# Public Comments on the Draft EIR for the Moraga-Oakland X 115 Kilovolt Rebuild Project

### **Re: Pacific Gas and Electric Company (PG&E) Moraga-Oakland X 115 Kilovolt Rebuild Project – Draft Environmental Impact Report (DEIR)**

PLAN VIEW  
ONE (1) DOUBLE CIRCUIT DUCT BANK  
BEND RADIUS EXAMPLE

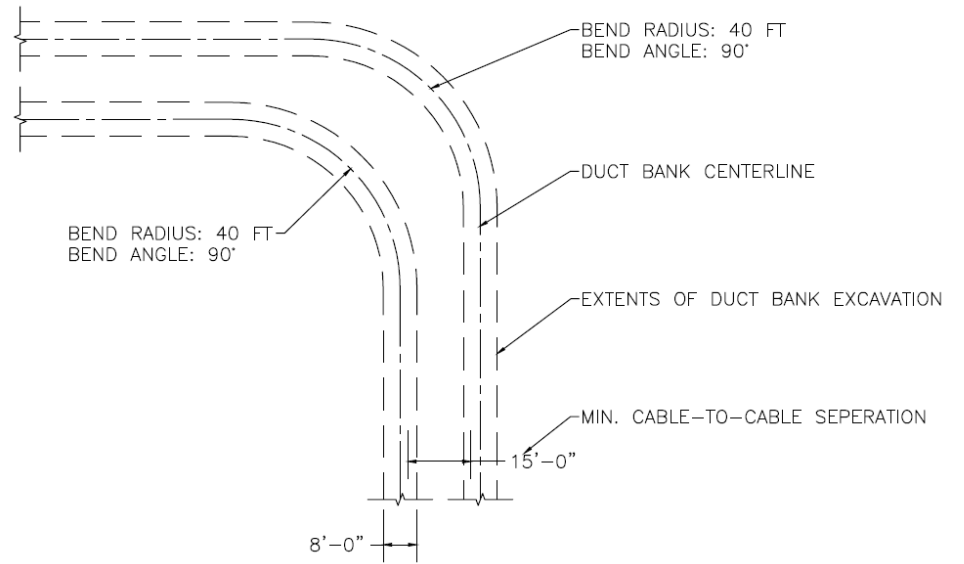
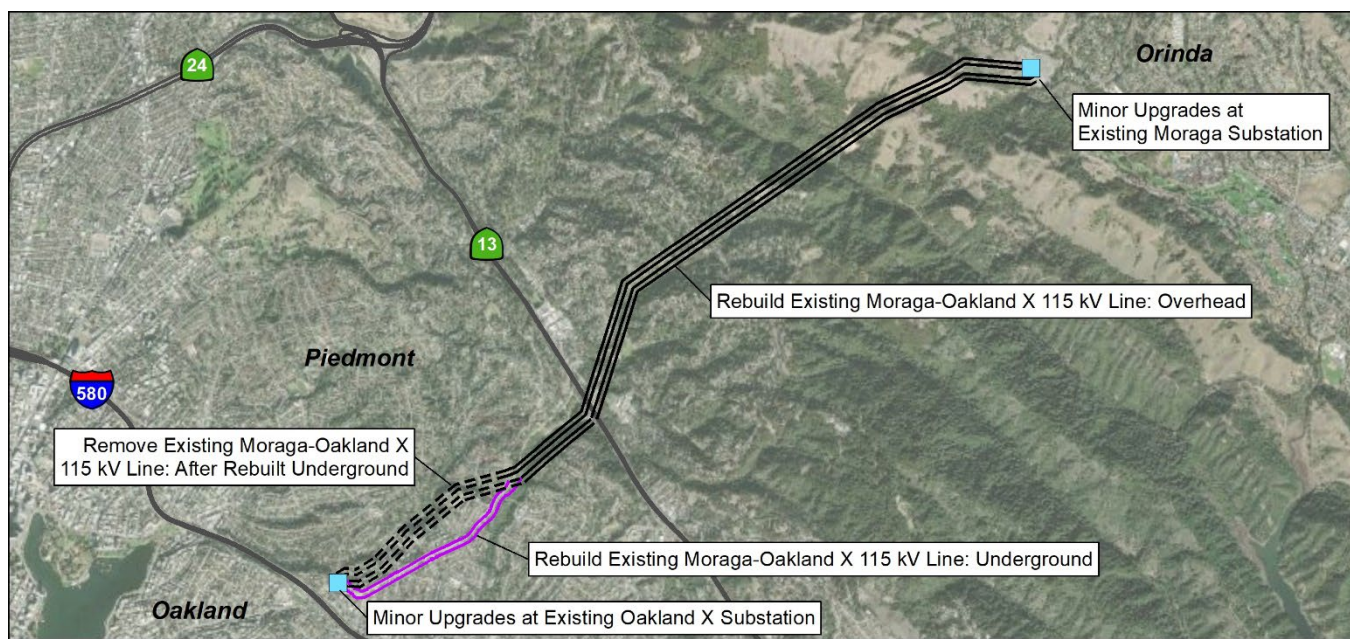
Attachment:  
Attachment 1 – ALT-1a Duct Bank Bend Radius Exhibit
